**UNITED STATES OF AMERICA
DEPARTMENT OF TRANSPORTATION
FEDERAL AVIATION ADMINISTRATION
RENTON, WASHINGTON 98055-4056**

Israel Aircraft Industries, Ltd.

**Regulatory Docket No.
FAA-2004-17212**

GRANT OF EXEMPTION

“Fig. 1: Emergency Exit Arrangement and 9g Barrier”

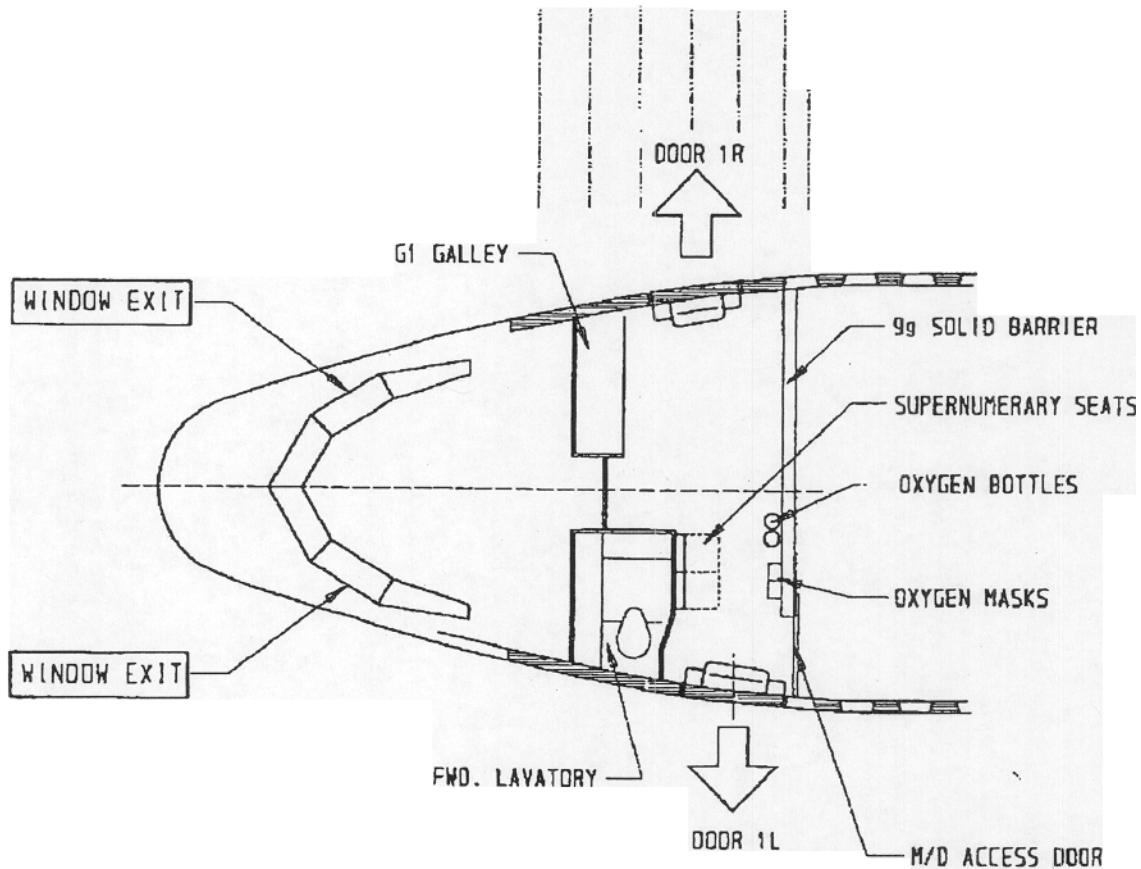
“b) Emergency Exits Arrangement and Accessibility (See Figure 1)

“With the rigid 9g barrier there is no need to modify the existing original aircraft emergency egress means. Both doors 1L and 1R remain active with their slides, markings and accessibility (on the 9g net configuration only door and slide 1R were available). These doors will be the primary emergency exit means for flight deck occupants and for the supernumeraries. Flight deck windows are not modified and remain in the original state (both openable from inside, window 2R also openable from outside). Due to the 9g-barrier location, however, there is no space for an attendant assist near door 1L.

- An exemption is requested from meeting FAR 25.813(b)(3) by not having space for assistance near the emergency exit door 1L.
- An exemption is requested from meeting FAR 25.857(e) to permit the flight of two non-crew passengers on a cargo aircraft with a class E cargo compartment.

Concerning the lack of an assist space adjacent to each exit, as required by § 25.813(b), the FAA has determined the two supernumeraries will have a higher level of training than a typical passenger, and will therefore have less need for crew assistance.

1. Occupancy outside the flightdeck is restricted to a maximum of two persons.
2. Supernumeraries are limited to the categories specified in § 121.583(a)(1) through (a)(7).
